**Zoning Ordinance Number 2004-O-33  
Amending General Implementation Plan  
for Lots 14, 15 and 16 First Addition to  
Fitchburg Technology Campus, and  
Issuing Specific Implementation Plan for  
Lot 14 First Addition to Fitchburg  
Technology Campus**

**ORDINANCE NO. 2004-O-33**  
**ZONING ORDINANCE AMENDMENT**  
**AMENDING PLANNED DEVELOPMENT DISTRICT GENERAL IMPLEMENTATION**  
**PLAN FOR LOTS 14, 15 AND 16 FIRST ADDITION TO**  
**FITCHBURG TECHNOLOGY CAMPUS AND**  
**ISSUING SPECIFIC IMPLEMENTATION PLAN FOR LOT 14**  
**FIRST ADDITION TO FITCHBURG TECHNOLOGY CAMPUS**

# FITCHBURG TECHNOLOGY CAMPUS BUILDING B-1

Site Plan

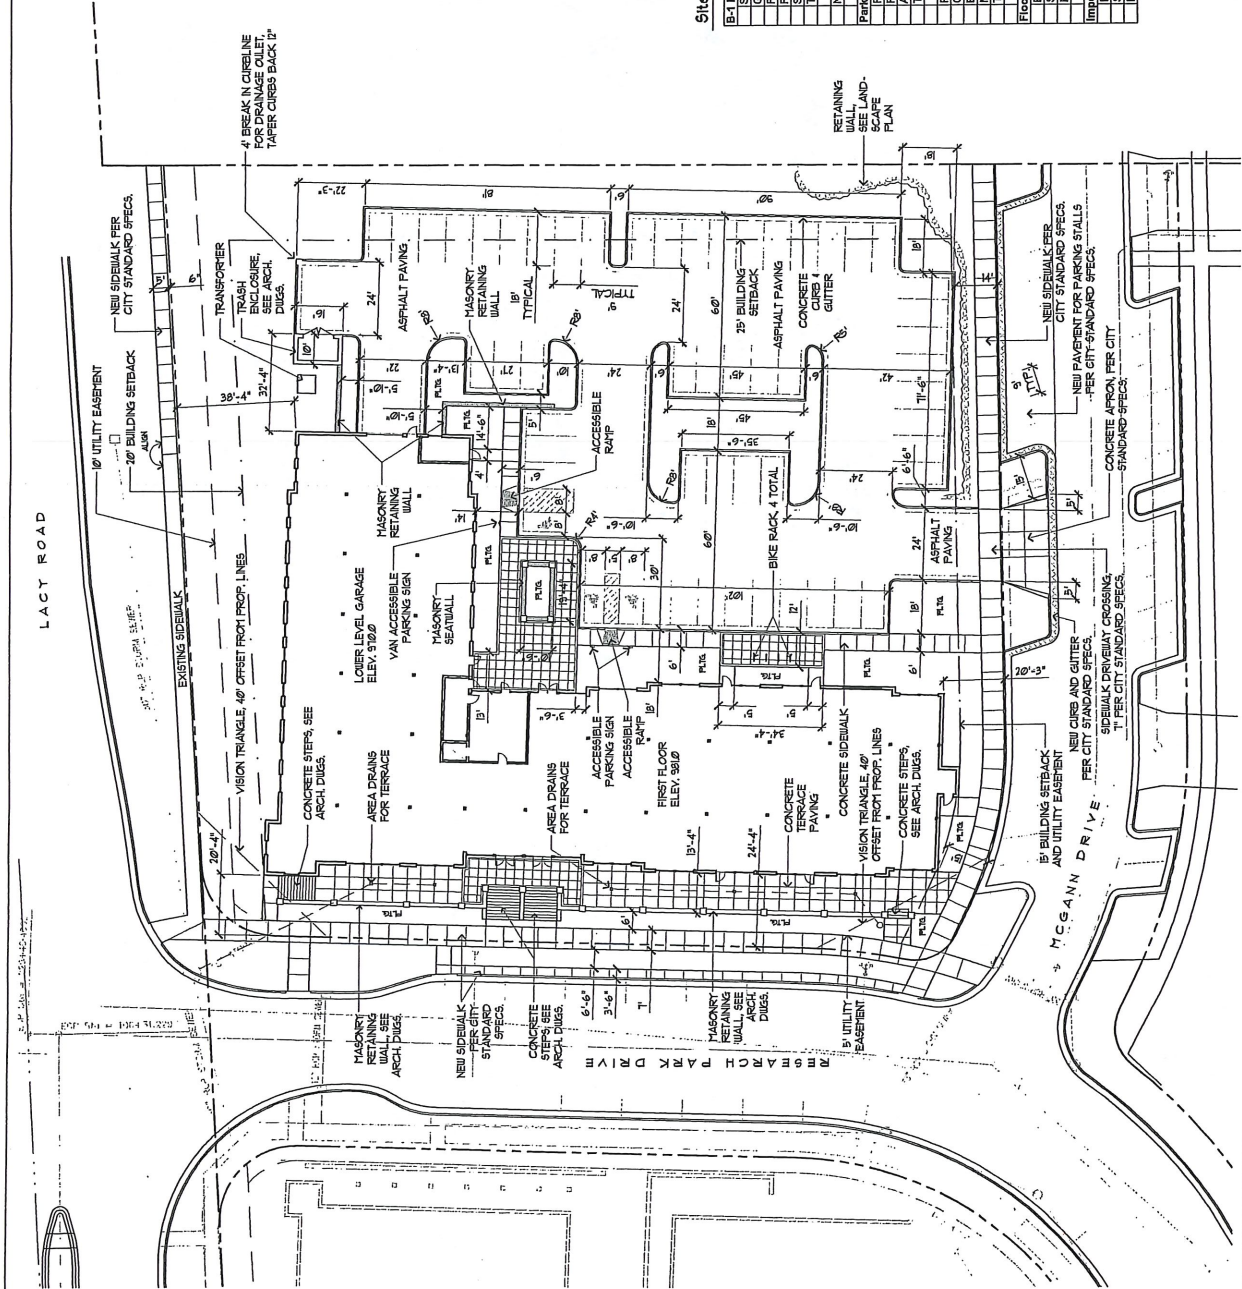
4. Site plans shall be amended to remove stairs from vision plane locations.
5. Payment of required park fees, prior to issuing any building permits, recognizing the new uses:

9. Impervious surface ratios for each site shall also be as noted on the 9/7/04 plan cover sheet.
10. 50' rear setback for lot 15 is allowed to include landscape steps from grass, parking or patio areas, but steps from buildings or decks shall not be allowed in the 50 foot setback.

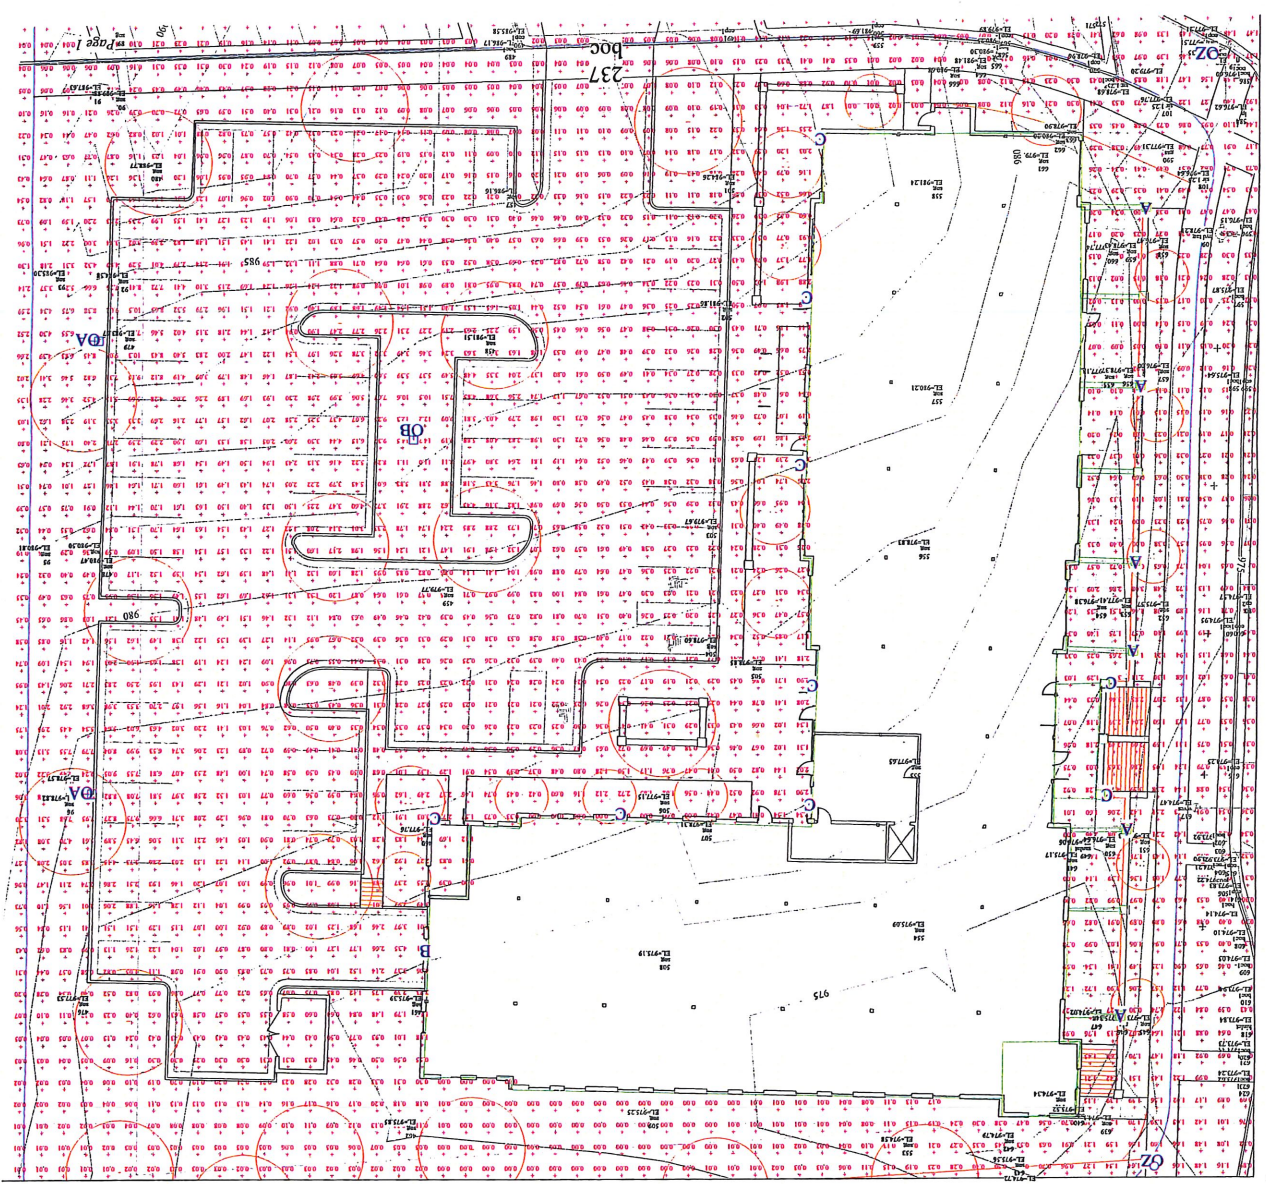
15. Applicants shall review, and have approved by staff modified exterior lighting plan to reduce light spill along the east portion of the site.
